In response to your telephone request of January 26, 1977, we are sending under separate cover 40 additional copies of the Watts Bar Nuclear Plant Environmental Information (November 18, 1976). This document updates the assessment provided by the Watts Bar Nuclear Plant Final Environmental Statement of November 1972.

WATTS BAR NUCLEAR PLANT UNITS 1 AND 2

ENVIRONMENTAL INFORMATION

This section identifies and discusses environmental aspects of those features relating to the design, construction, and operation of the Watts Bar Nuclear Plant which have been revised since the FES was published on November 9, 1972. There are nine general items discussed in this section. These are: (1) Watts Bar/Volunteer 500kV Transmission Line, (2) Location of blowdown diffusers, (3) Tritium disposal method, (4) water chemistry changes, (5) minor changes in construction practices, (6) visitor facilities, (7) addition of condensate demineralizers, (8) addition of radwaste evaporator and (9) other changes, miscellaneous items.

FIGURE 2.5-1
FLOW DIAGRAM - DISCHARGE
OF PLANT LIQUIDS
(REVISED)

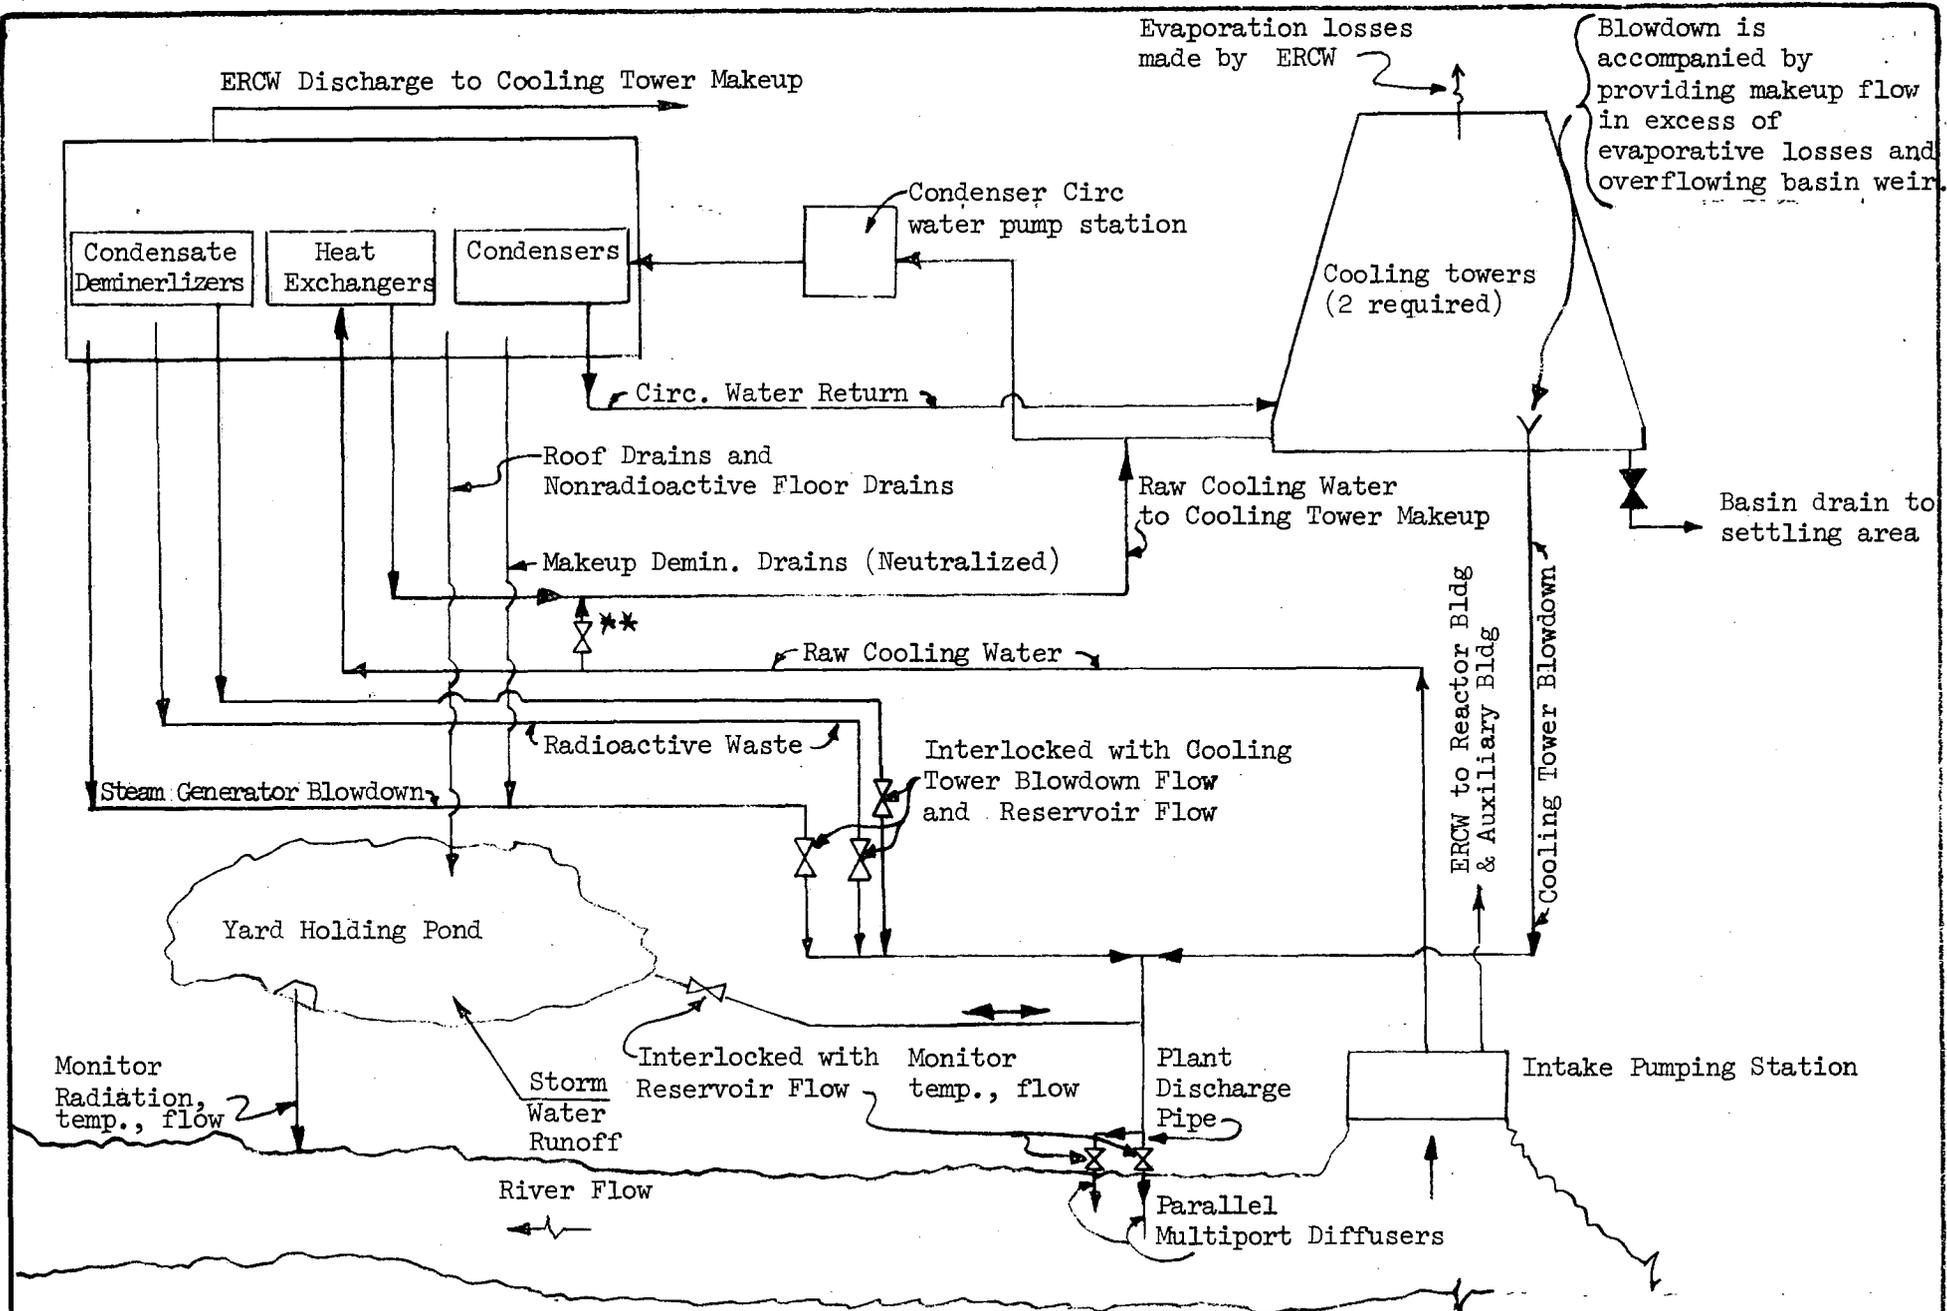
On page 2.5-8 of the Watts Bar Nuclear Plant FES, it was stated that wastes from the Makeup Water Filter Plant would be routed to a lagoon area and, as necessary, the sludge would be disposed of by burial on TVA property. It is now planned to dewater flocculator sludge and filter backwash to a product containing about 50 percent solids and bury this solid waste in an offsite approved sanitary landfill. The system has been designed to treat approximately 20,000 gallons of liquid.

Treatment of demineralizer wastes will no longer employ a weak cation resin neutralizer. A batch neutralization process that monitors and adjusts the pH to meet applicable discharge requirements will be used instead. The estimated quantities of chemicals to be discharged to the environment from the makeup demineralizer system have not changed from those previously listed in Table 2.5-1 of the Watts Bar Nuclear Plant FES. (A revised version of this table is included at the end of the discussion in this section on WATER CHEMISTRY CHANGES.) Findings of TVA's environmental review of the overall impact of nonradioactive chemical discharges are presented in Section B of this transmittal. Additionally, the reference to possible use of coagulation aids in the filter plant (see page 2.5-8 of the FES) cites an EPA approved list which may be out of date when

FIGURE 2.5-1
FLOW DIAGRAM - DISCHARGE
OF PLANT LIQUIDS
(REVISED)

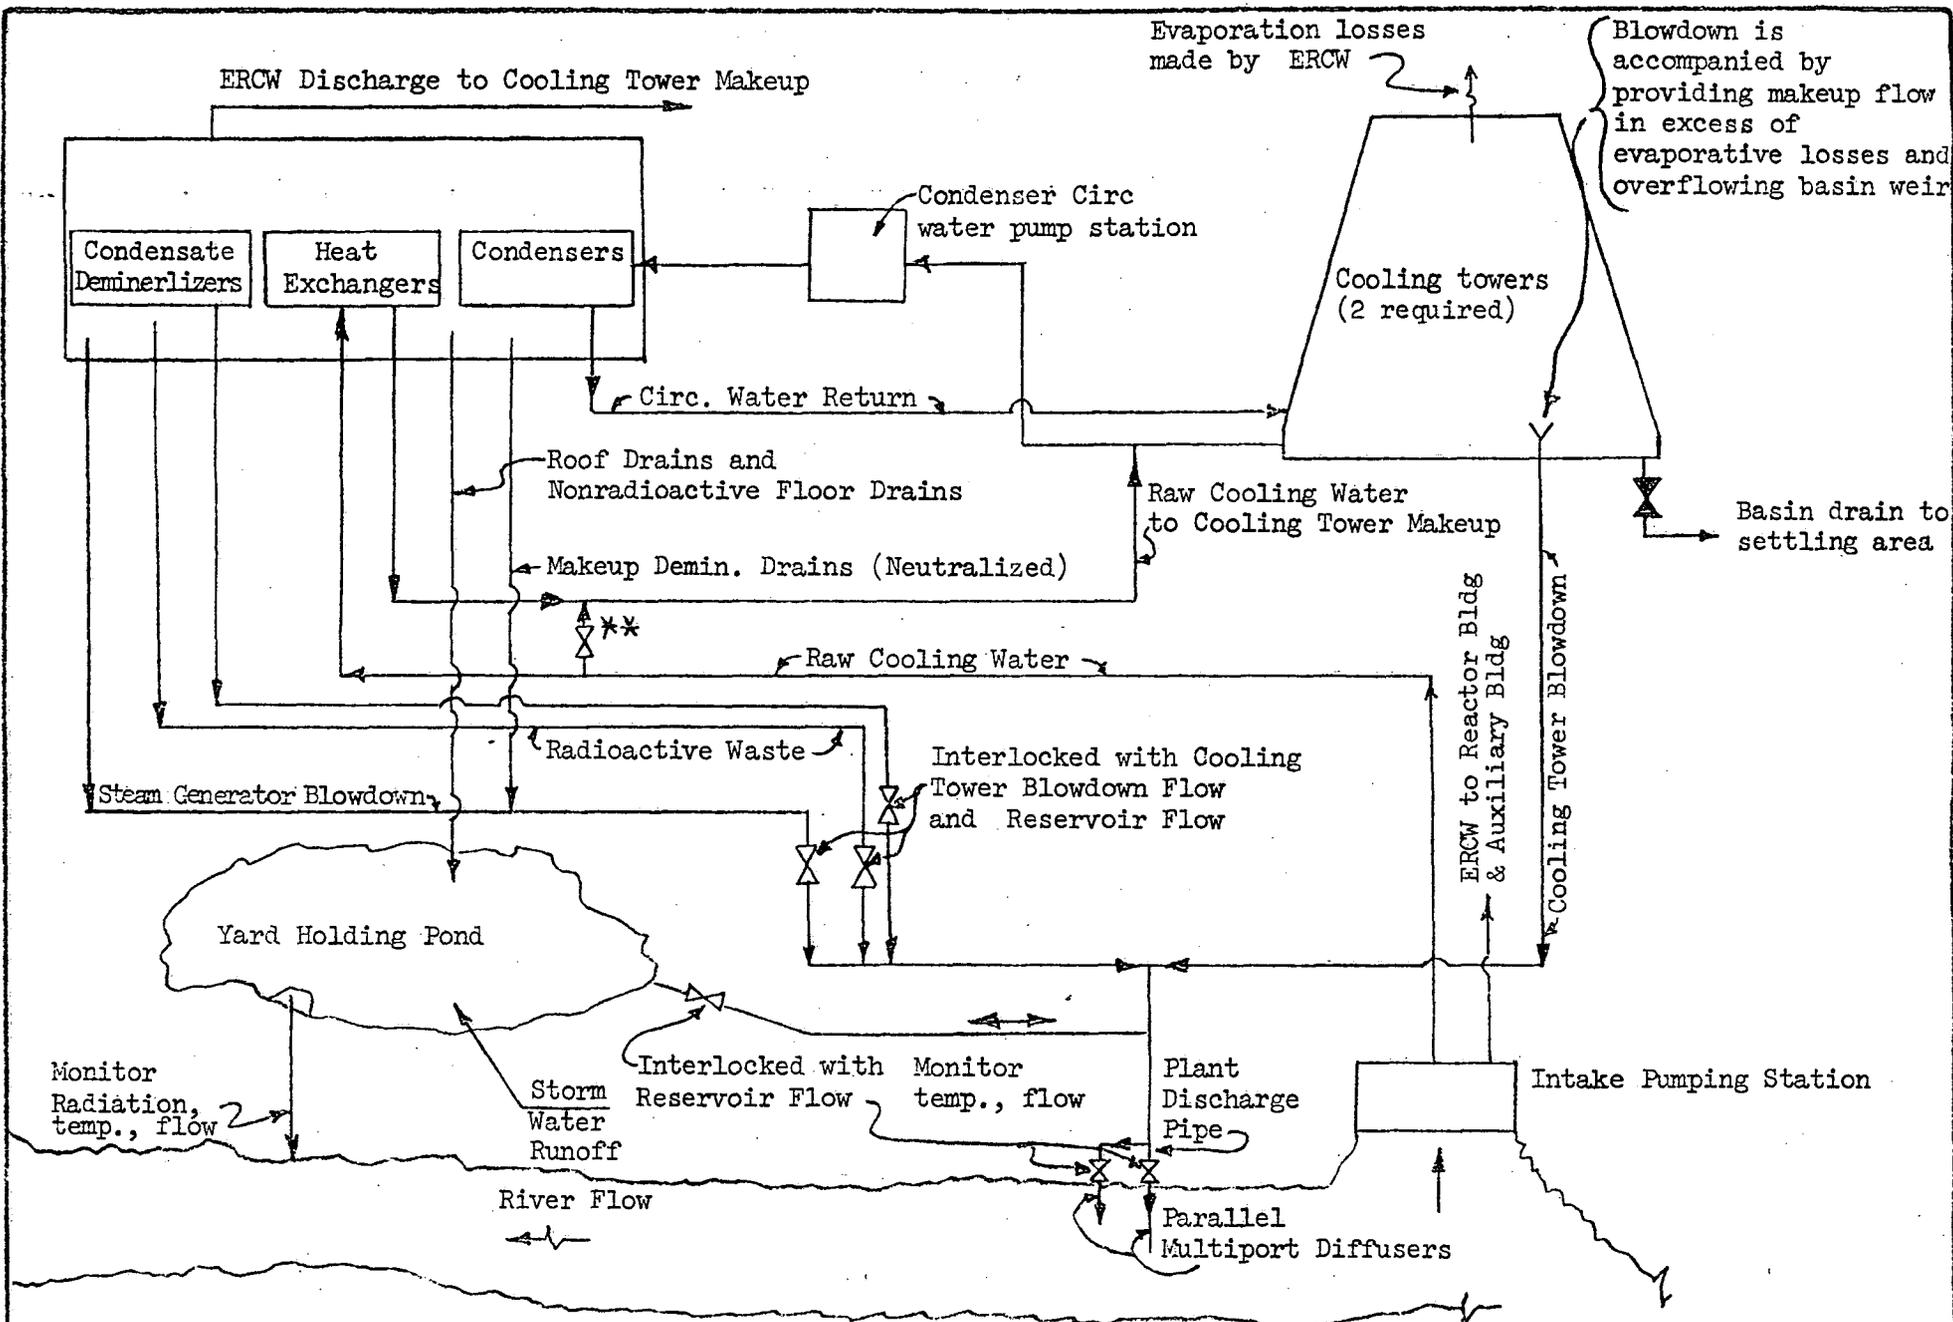
- (1) acknowledgement of the need to obtain NPDES permits,
- (2) the assessment of corrosion losses within the cooling systems,
- (3) the changes in plant operation to provide for continued blowdown from the Condenser Cooling Water (CCW) System,
- (4) the use of chlorine (in the hypochlorite form) as a molluscicide rather than acrolein,
- (5) the change in waste treatment methods for the makeup water filter plant and the makeup demineralizer wastes,
- (6) the addition of condensate demineralizers, and
- (7) a revised description of the proposed method of treating chemical cleaning wastes.
